Access Compliance Report

Public Rights-of-Way

Intersection ID: 10997	Main Street: DORA_DR	Cross Street: GLENVILLE_AV	Location: S
ADA ID: 9D794F0C9A18	Ramp Type: Perp	Initial Pass/Fail: Fail	Overall Compliance: No
		Severity Score: 10

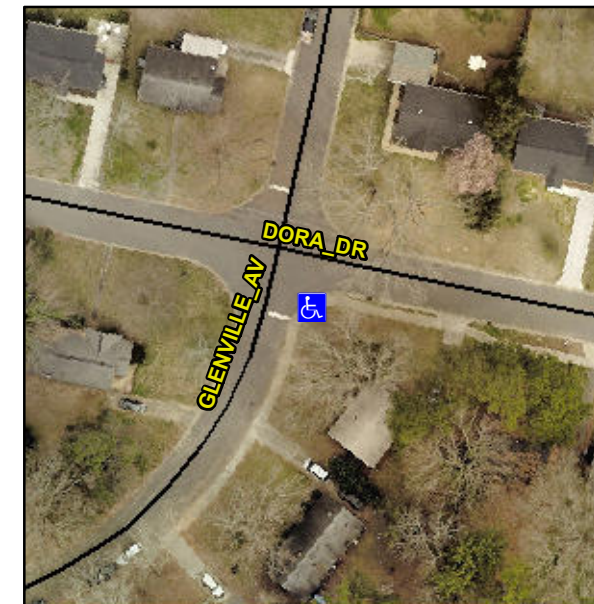
Not Found, R304.5.1

Compliance	Description	Data	Compliance	Description	Data
N/A	Ramp Length (in)	59.0	Yes	Ramp Slope (%)	6.6
No	Ramp Width (in)	46.5	Yes	Ramp XSlope (%)	2.5
N/A	Flare Type LT	N/A	N/A	Flare Type RT	N/A
N/A	Flare Slope LT (%)	N/A	N/A	Flare Slope RT (%)	N/A
N/A	Flare Traversable LT?	N/A	N/A	Flare Traversable RT?	N/A
N/A	Landing Length (in)	N/A	N/A	DWS Provided?	N/A
N/A	Landing Width (in)	N/A	N/A	DWS Contrast?	N/A
N/A	Landing Slope (%)	N/A	N/A	DWS Length (in)	N/A
N/A	Landing X Slope (%)	N/A	N/A	DWS Full Width?	N/A
N/A	Landing Curb? (Y/N)	N/A	N/A	DWS Offset (in)	N/A
N/A	Shared Landing?	N/A			
N/A	Gutter Ponding?	N/A	N/A	Gutter Slope (%)	N/A
N/A	Gutter Lip Ht (in)	N/A	N/A	Gutter X Slope (%)	N/A
N/A	Painted X Walk1?	No	N/A	Painted X Walk2?	N/A
	X Walk 1 Direction	To N		X Walk 2 Direction	N/A
N/A	X Walk 1 Width (in)	N/A	N/A	X Walk 2 Width (in)	N/A
	X Walk 1 Slope (%)	0.2		X Walk 2 Slope (%)	N/A
	X Walk 1 X Slope (%)	2.9		X Walk 2 X Slope (%)	N/A

Remove & Replace Entire Ramp.
